APPLICATION NO.	FILING DATE	FIRST NAMED INVENTOR	ATTORNEY DOCKET NO.	CONFIRMATION NO.
10/579,284	07/14/2008	Martin Schlegl	710.1045	8914
	7590 04/15/200 dson & Kappel, LLC	EXAMINER		
485 7th Avenue			TIETJEN, MARINA ANNETTE	
14th Floor New York, NY 10018			ART UNIT	PAPER NUMBER
			3753	
			MAIL DATE	DELIVERY MODE
			04/15/2009	PAPER

Application No.	Applicant(s)			
	10/579,284	SCHLEGL ET AL.			
Office Action Summary	Examiner	Art Unit			
	MARINA TIETJEN	3753			
The MAILING DATE of this communication app Period for Reply	ears on the cover sheet with the c	orrespondence address			
A SHORTENED STATUTORY PERIOD FOR REPLY WHICHEVER IS LONGER, FROM THE MAILING DA - Extensions of time may be available under the provisions of 37 CFR 1.13 after SIX (6) MONTHS from the mailing date of this communication. - If NO period for reply is specified above, the maximum statutory period w - Failure to reply within the set or extended period for reply will, by statute, Any reply received by the Office later than three months after the mailing earned patent term adjustment. See 37 CFR 1.704(b).	ATE OF THIS COMMUNICATION 36(a). In no event, however, may a reply be tim vill apply and will expire SIX (6) MO

Schwaiger discloses a lightweight valve (fig. 2) comprising:

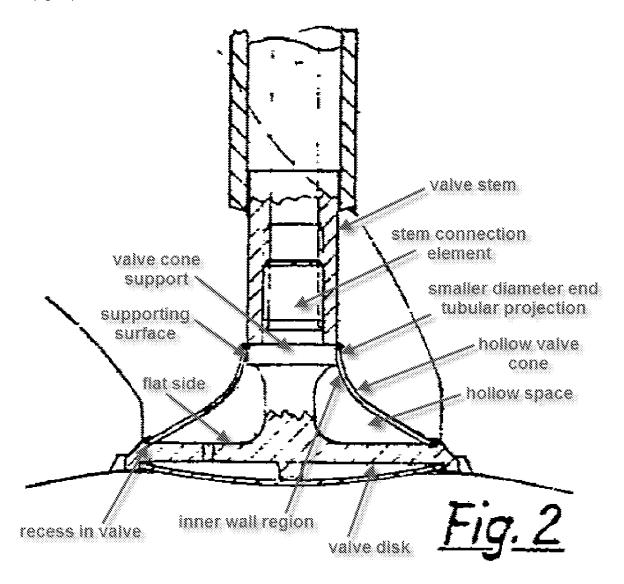
a valve stem (see labeled fig. 2 below);

a hollow valve cone (see labeled fig. 2 below) with a hollow space (see labeled fig. 2 below);

a valve disk (see labeled fig. 2 below) closing the hollow space (fig. 2) on one side and having a flat side (see labeled fig. 2 below) facing the valve cone (fig. 2);

the valve stem (fig. 2) being connected to a stem connection element (labeled fig.

2) formed on or fastened to the valve disk (fig. 2);

a valve cone support (see labeled fig. 2 below) located at a distance from the valve disk (fig. 2) and provided in the hollow space (fig. 2), the valve cone support (fig.

2) being located on the stem connection element (fig. 2) and projecting above the flat side (fig. 2);

wherein the valve cone support (fig. 2) includes at least one supporting surface (see labeled fig. 2 above) bearingly contacting an inner wall region (see labeled fig. 2 above) of the valve cone (fig. 2);

wherein a contour of the supporting surface (fig. 2) complements the inner wall region (fig. 2);

wherein the valve cone support (fig. 2) is formed by a thickening on the stem connection element (fig. 2);

wherein the valve cone is of disk-spring-shaped design (cone creates concave shape, fig. 2);

wherein the valve cone (fig. 2) has at a smaller diameter end (see labeled fig. 2 above) a tubular projection (see labeled fig. 2 above) for guiding through the stem connection element (fig. 2);

wherein the valve cone support (fig. 2) forms a centering and supporting seat for the valve cone (fig. 2);

wherein the valve disk (fig. 2) has a recess (vaguely shown in fig. 2, but better shown in fig. 6) serving as a centering and supporting seat for the valve cone (fig. 2); and

wherein the valve (fig. 2) is an internal combustion engine valve.

Meintschel et al. teach a lightweight valve (21, fig. 3) comprising:

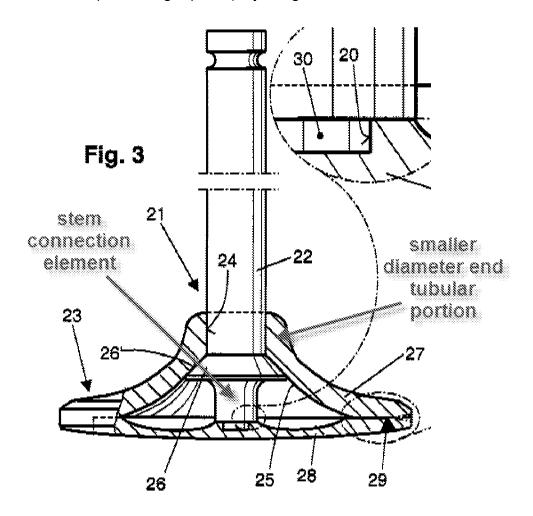
4. Claims 1-17 and 19 are rejected under 35 U.S.C. 102(a) as being anticipated by Meintschel et al. (DE 10204122).

a valve stem (22);

a hollow valve cone (27) with a hollow space (inside cone, fig. 3); and

a valve disk (28) closing the hollow space on one side and having a flat side (flat side contacts valve cone) facing the valve cone (27);

the valve stem (22) being connected to a stem connection element (see labeled fig. 3 below) fastened to the valve disk (28);

a valve cone support (26) located at a distance from the valve disk (28) and provided in the hollow space, the valve cone support (26) being located on the stem connection element (labeled fig. 3) and projecting above the flat side;

wherein the valve cone support (26) includes at least one supporting surface (surface contacting cone surface 25) bearingly contacting an inner wall region (25) of the valve cone (27);

wherein a contour of the supporting surface (contacts cone surface 25) complements the inner wall region (25);

wherein the valve cone support (26) is formed by a thickening on the stem connection element (labeled fig. 3);

wherein the valve cone (27) is of disk-spring-shaped design (cone has concave shaped surface like a disk-spring);

wherein the valve cone (27) has at a smaller diameter end (see labeled fig. 3 above) a tubular projection (see labeled fig. 3 above) for guiding through the valve stem (22);

wherein the valve cone support (26) forms a centering and supporting seat for the valve cone (27); and

wherein the valve (21) is an internal combustion engine valve.
